INDEX

TIMELY OPE TIPS FOR THE MONTH - 1982

TIMELY TIPS FOR THE MONTH

ISSUE # 95

TIP # 1 - Attachment Drive Clutch Pulley Spacer Change:

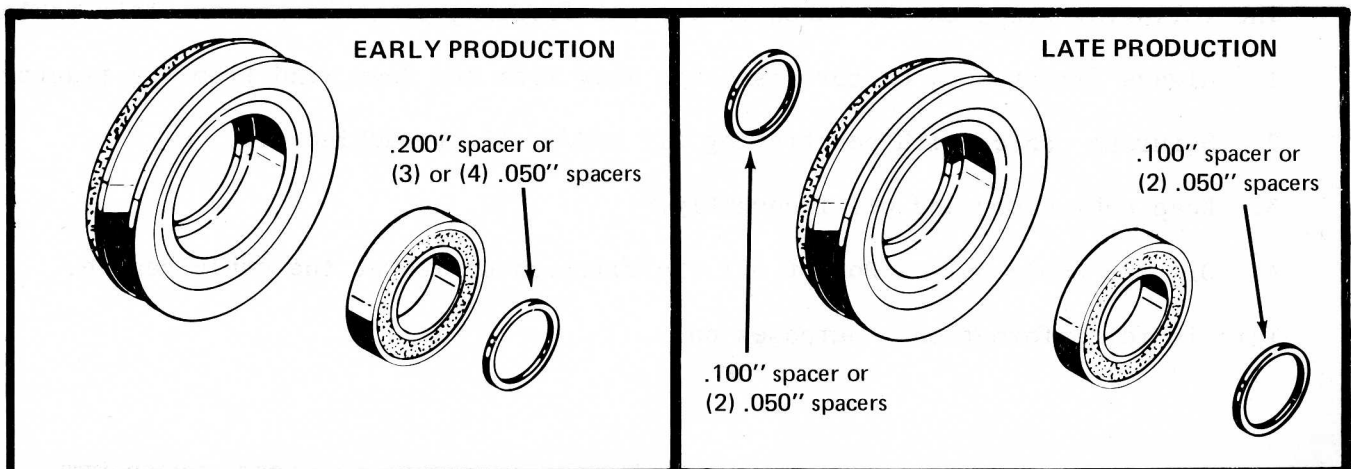
The position of the bearing in the attachment drive clutch pulley has been changed. The bearing is now centered under the pulley V-Groove.

To accommodate this change, the .200" spacer (or 3 or 4 .050" spacers) between the pulley and rear cam has been eliminated.

A .100" spacer, P/N C26346, (or 2 .050" spacers, P/N C15557) is now used on each side of the pulley bearing.

TIP # 1 - RER 80 Muffler Bolt Added:

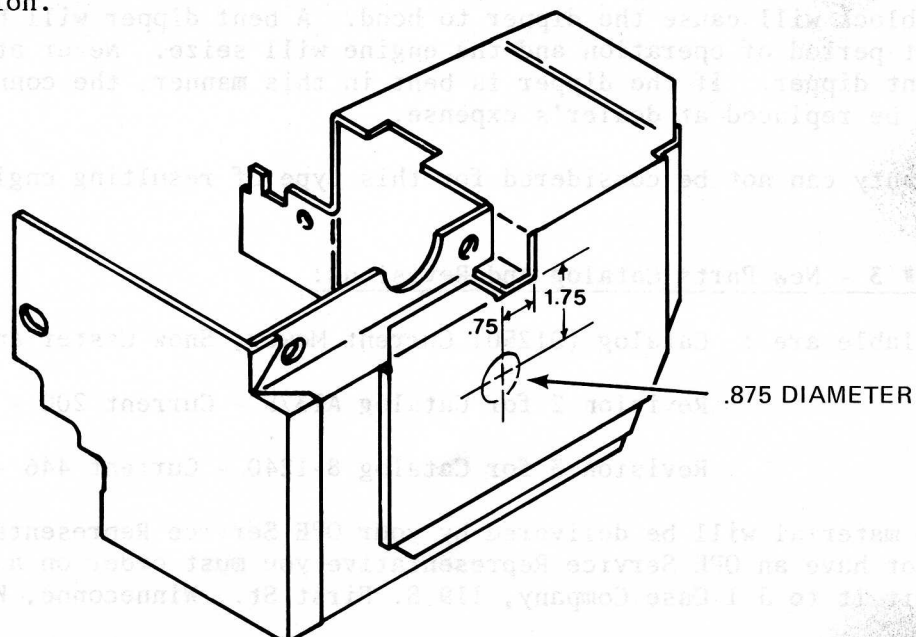
As a result of some reports from the field of the two muffler shoulder bolts stripping out or breaking after extended hours of use, a third bolt has been added to secure the muffler anchor tab to the cylinder head. This change was made on the Model 80 RER effective with P.I.N. 14015151.

Although the problem potential is not deemed sufficient to warrant a mandatory field modification, we are requesting the third bolt be added to the muffler on all Model 80's in dealer inventory between above P.I.N. and P.I.N. 9776118 when the new muffler went into production. This should be done at the time the mowers are being predelivered. Also, when retail units are in for service between these two P.I.N.'s we are requesting that the third bolt be added at that time.

1. Remove the engine enclosure and battery.
2. Center punch a pilot mark in the air duct according to the following illustration.

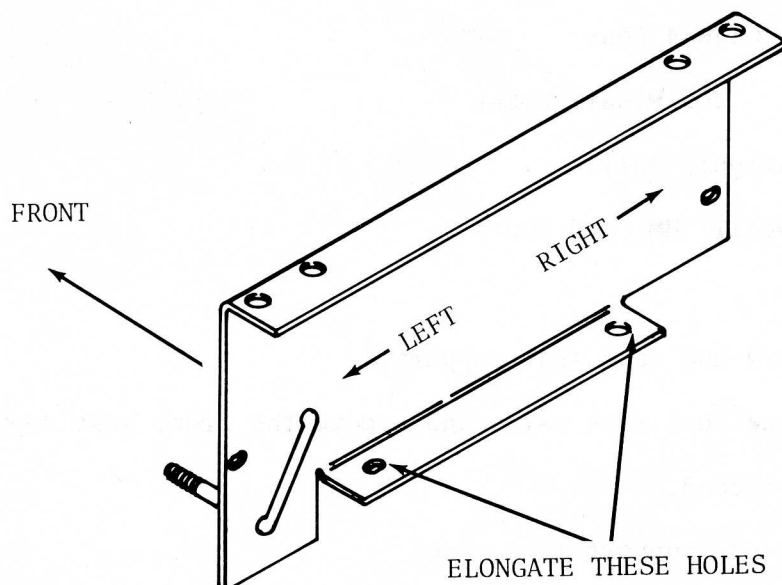
Push the lever "down" into high range as far as it will go and release it.

The distance between the top edge of the lever and the bottom edge of the pin must not be more than .12 inch (3.2 mm).

If the distance exceeds .12 inch (3.2 mm), remove the seat support and increase the slot size.

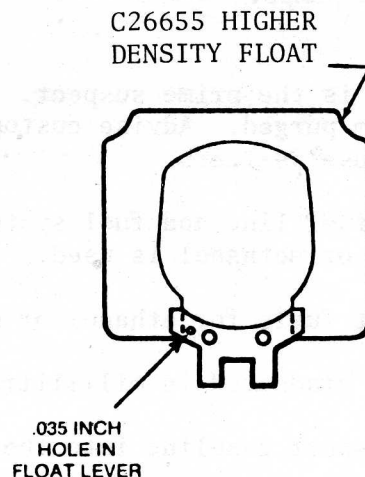
The higher density float, P/N C26655, has also been available in Service Parts Supply since mid September. The new P/N C26655 float can be identified by an extra .035" hole in the float lever as illustrated.

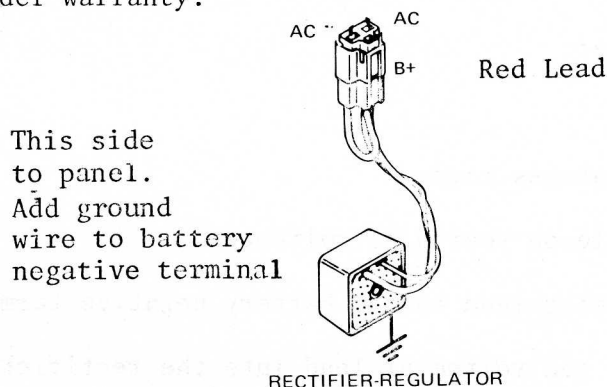
10. If the voltage increases from battery voltage to a range of 13.6 to 14.7 volts, the rectifier regulator is good. Install the rectifier regulator as shown and add a ground wire.

11. If the voltage does not increase above battery voltage, the alternator must be checked.
12. Disconnect your voltmeter from battery and select the 40 volt AC scale. This test must be done with an AC voltmeter.

TIP #1 - Installation Change for P/N C25485 Rectifier Regulator

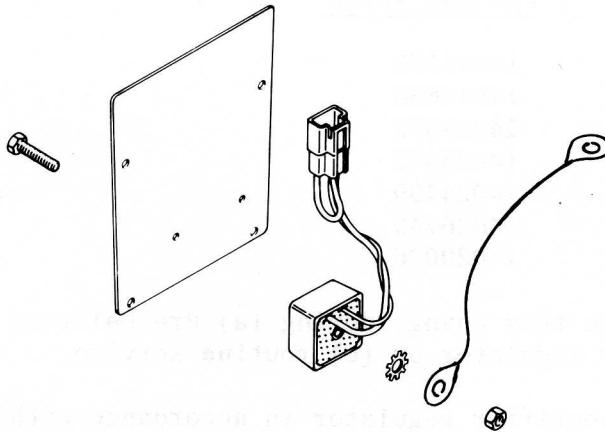
- a) the 'star' washer between the rectifier regulator and rear access panel is moved.
- b) a ground wire is added from the rectifier regulator to the battery negative terminal.

1. Make a grounding wire.
 - a) 18 gauge
 - b) 29 inches (740 mm) long
 - c) 1/4 inch (7 mm) ring terminal on each end
2. Remove the rear access panel.
3. Remove the nut holding the rectifier regulator

4. Remove the "STAR" washer from between the rectifier regulator and rear access panel.

TIP # 3 - Tubing Clamp Added to J17, L17 Hydraulic PTO Kits:

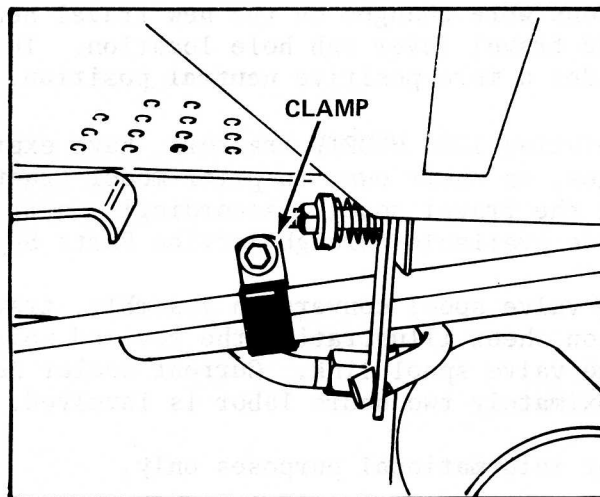
Beginning with J17, L17 Hydraulic PTO Kits built on 8/30/83 a P/N L71188 clamp is included to hold the tubes to the left side tractor frame rail. The clamp was added to prevent possible interference between the PTO tubes and the Hi-Low range shift lever.

Use the following procedure to install the clamp.

Use the clamp to secure the hydraulic tubes to the tractor left side frame rail. Locate the clamp about 4 inches (100 mm) forward of the two speed transaxle shift lever and with the bolt hole up.

TIP # 1 - Snow Caster Lift Arm Clearance for 1984 200 Series Tractors:

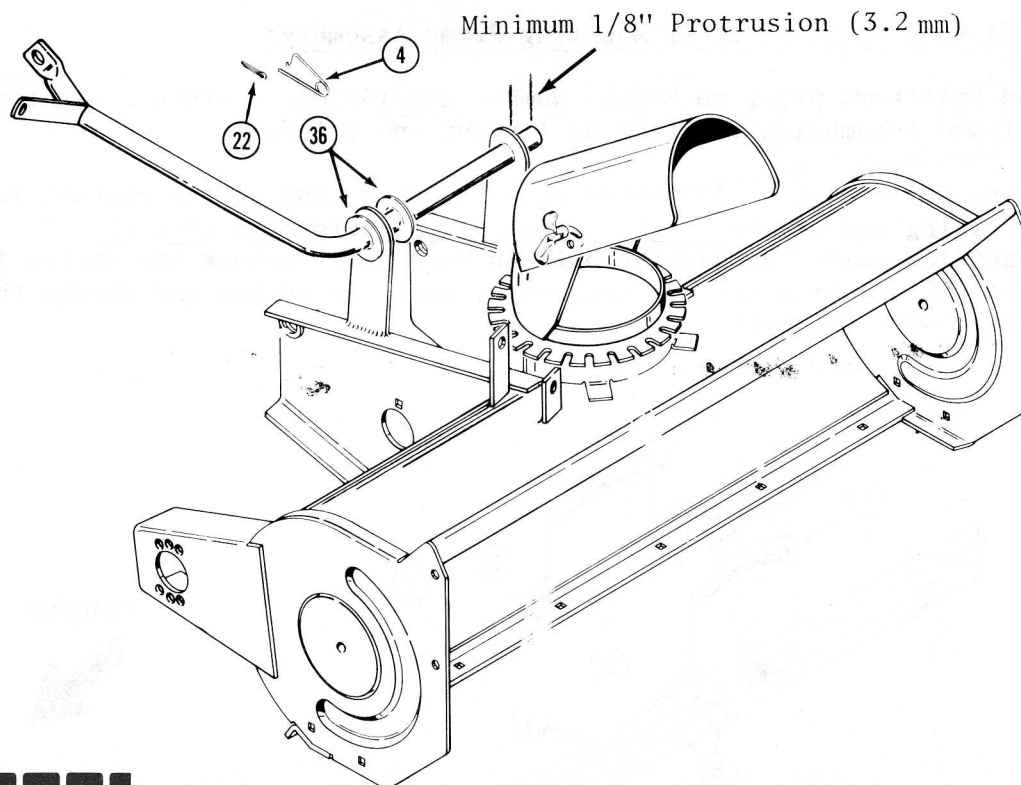
The lift arm on 38" and 48" snow casters prior to the serial numbers listed below may interfere with the hood on 1984 Model 200 series tractors.

To overcome this interference, shift the lift arm to the right until a minimum of 1/8" protrusion through the left support exists. Position the washers (36) as pictured and drill new holes for the cotter pin and safety pin (items 22 and 4 respectively).
